KING'S MARK ENVIRONMENTAL REVIEW TEAM

**COMMUNITY HOMEBUILDERS
SUBDIVISION**

BARKHAMSTED,
CONNECTICUT

Environmental Review Team Report

Proposed Site Plan

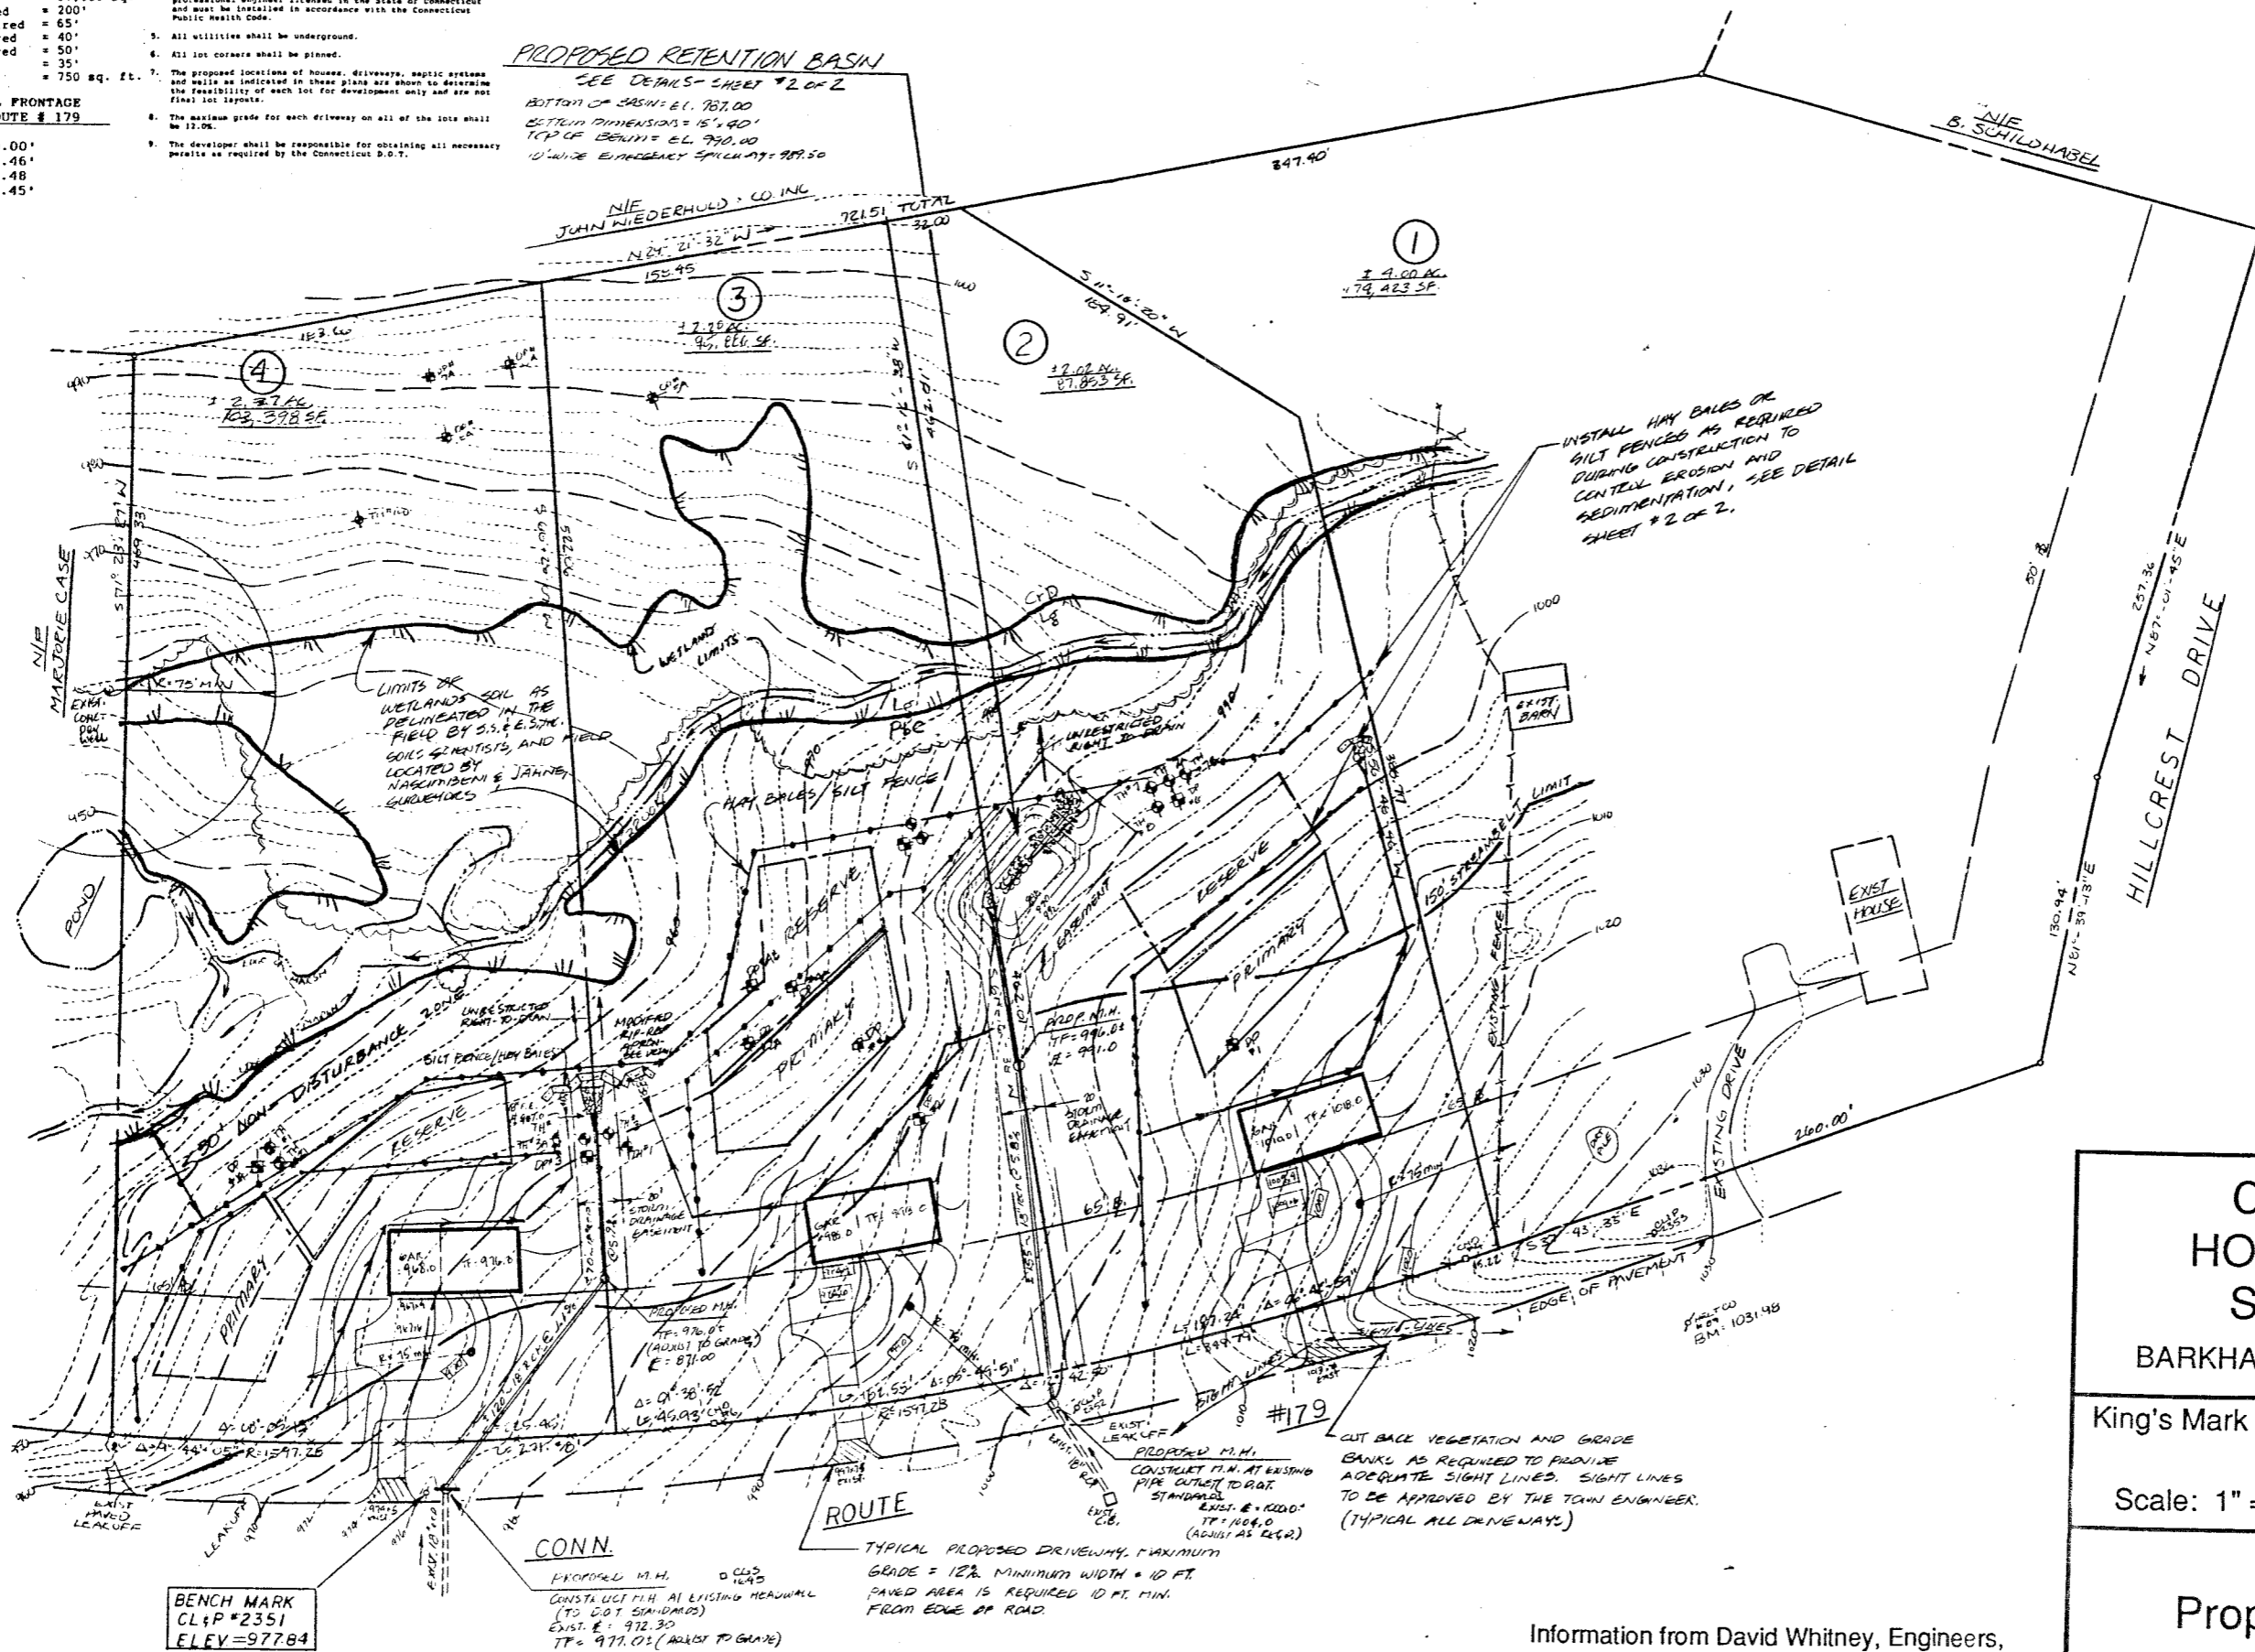
- 1) The storm drain pipe outlet between Lots 3 and 4 and the detention pond outlet pipe should be carried to the toe of the slope. If outlets remain where shown, a stable channel should be designed to carry water over the slope to the watercourse. The storm drain easement should be extended accordingly.

- 2) The curtain drains from Lots 3 and 4 could use the same rock lined outlet as the storm drain pipe, reducing the amount of rock needed.
- 3) The east side of the detention pond is excavated into the ground. Some ground seepage may be encountered in this cut bank, causing soil erosion. A subsurface drainage pipe could help alleviate this situation.

- 4) Hydraulic calculations should be supplied to the Town showing pre- and post-development runoff (recommended storms are the 2, 10 and 100 year, 24 hour, type III storms). This data should be reviewed by a professional engineer.

- 5) Responsibility for the drainage system and detention basin maintenance should be clarified. The embankment of the detention pond should be maintained free of trees and shrubs.

- 6) Sediment should be removed from the detention basin periodically so that the capacity is not reduced, and outlet pipe is not buried.

- 1) The proposed non-disturbance zone should be extended to both sides of the wetland system. The wetland permit should indicate exactly what activities may or may not occur within those areas, (i.e. no chemical fertilizers, landscaping or clearcutting, no building of structures, etc.).

- 3) Specific conditions concerning the cleaning and maintenance of the detention basin on Lot 2 should be agreed upon. If the Town of Barkhamsted undertakes this responsibility, some form of access or right of way to the retention basin should be established. If the responsibility of cleaning and maintenance is given to the developer or the future lot owner, some sort of performance bond should be designated.
